SERVICE MEMORANDUM

MGF/26

JAMMING IN GEAR

MAGNETTE ZA & ZB
MAGNETTE Mark III
MGA

IH 3092

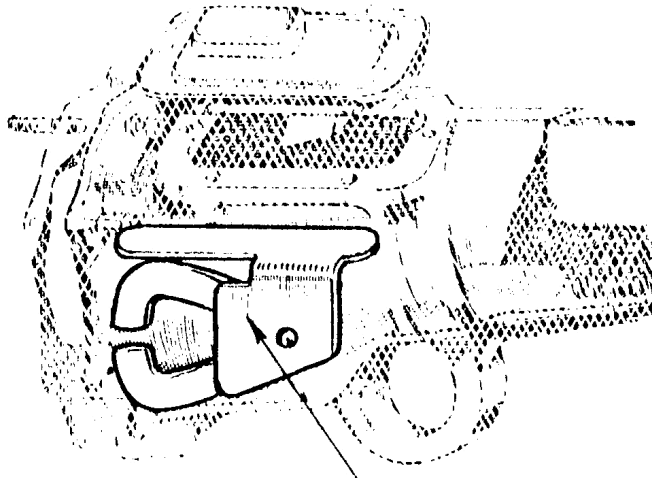
Complete replacement gearboxes are often fitted to remedy this trouble but such drastic measures are quite unnecessary, the fault being almost certainly due to looseness in the riveting of the interlocking arm assembly IH3092 (see sketch).

Such looseness allows the interlocking arm to ride over the selectors and rectification consists merely of replacing the interlocking arm assembly.

Should a replacement be unavailable, the existing assembly - provided it is undamaged - may be made good by re-riveting the arm to the plate. In some cases all that is required is the tightening of the existing rivet.

An indication of the correct tightness is given by the Belleville washer between the arm and the plate. This should be quite flat.
